Groundwater Transfer Review Summary Form

Transfer/PA # T- 14369

Application: T-14369

Applicant Name: Jason Karam

Modeled Interference: Proposed Well 3 to MULT 107461

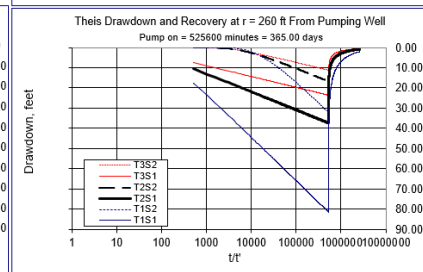
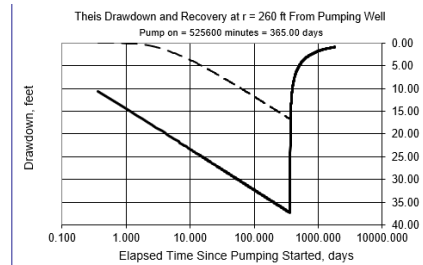
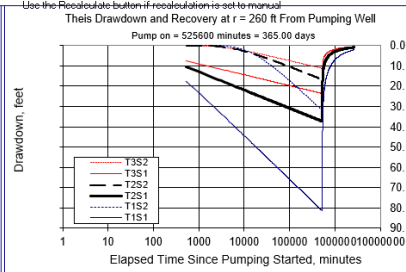
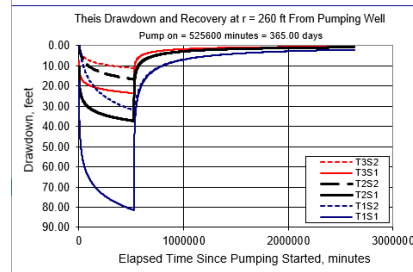
4. ☐ Yes ☒ No If yes, explain: The potential interference between Well 3 and MULT 107461 was evaluated with the maximum authorized rate of 300 gpm. The results are shown on the attached figures. Under more conservative aquifer parameters, drawdown may temporarily exceed 25 feet, particularly during irrigation season pumping; however, under all aquifer parameter scenarios evaluated, the total drawdown equilibrates to less than 25 feet. Therefore, the proposed change is unlikely to result in another groundwater right not receiving the water to which it is legally entitled.

Modeled Stream Depletion: Proposed Well 6 to Kelly Creek

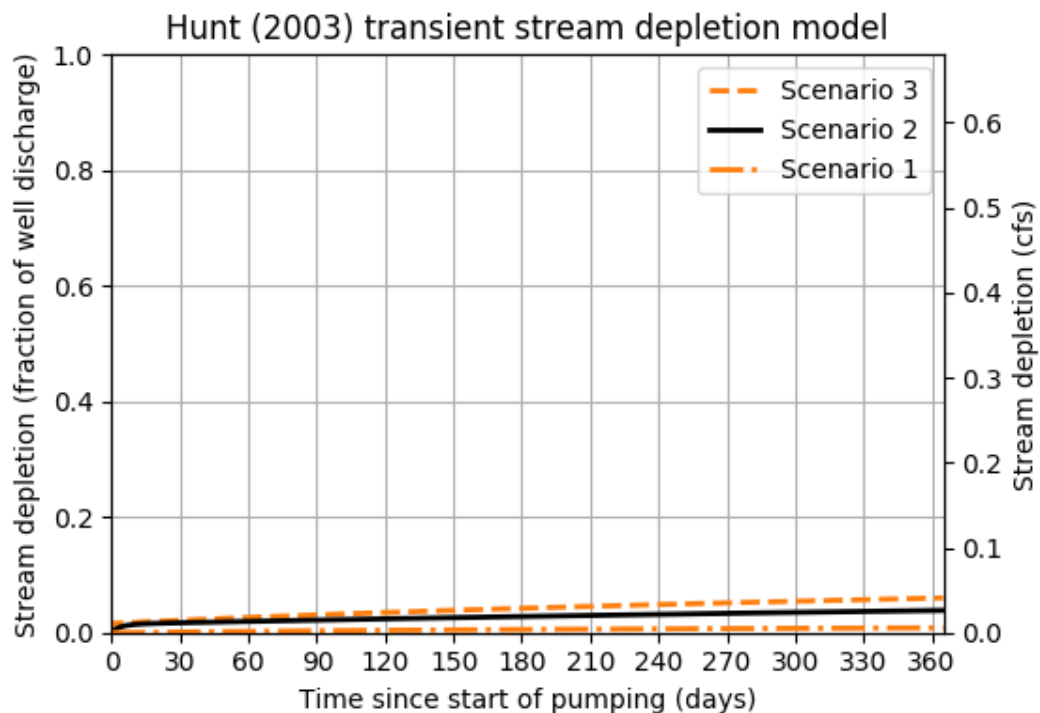
5. a) Will this proposed change, at its maximum allowed rate of use, likely result in an increase in interference with **another surface water source**?
☒ Yes ☐ No Comments: Currently authorized POA MULT 2301 is approximately 1,160 feet north of Kelly Creek. The locations for proposed APOAs Well 2, Well 3, and Well 6 would be approximately 350 to 840 feet north of Kelly Creek. The reduced intervening distance is likely to result in an increase in interference with Kelly Creek.

- b) If yes, at its maximum allowed rate of use, what is the expected change in degree of interference with any **surface water sources** resulting from the proposed change?
Stream: Kelly Creek ☒ Minimal ☐ Significant
Stream: _____ ☐ Minimal ☐ Significant
Provide context for minimal/significant impact: The Hunt 2003 analytical stream depletion

model was used to estimate the maximum potential interference at Kelly Creek caused by the proposed change. Model parameters are derived from nearby pumping tests and published values (Freeze and Cherry, 1979). Model results indicate that interference is expected to increase by 1 to 2%. Therefore the anticipated change in interference is expected to be minimal.
